Order No.: DD+DIS166.02E

**ADC Solo**

**Path Speed CR SP1001**

## Replacement of a broken light barrier flag at the Cassette Opener

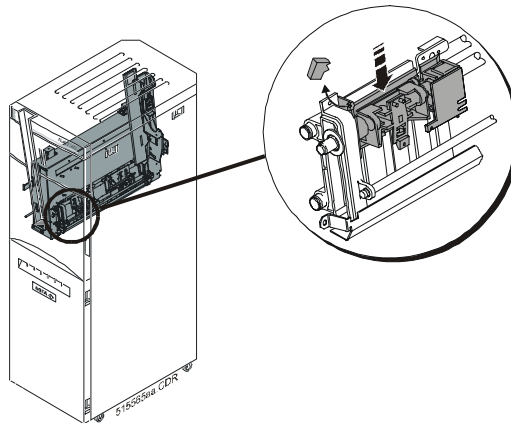
The light barrier flag (see figure beside) of the cassette opener may break when it touches the frame of the cassette opener.

The cassette opener (LHS) remains in the home position and is not moved to the middle position when the cassette holder is lowered manually.

Exchange the broken part.

Order number: **CM+9.5146.5911.0**

Spare part can be ordered separately. It is not necessary to order a complete cassette opener!
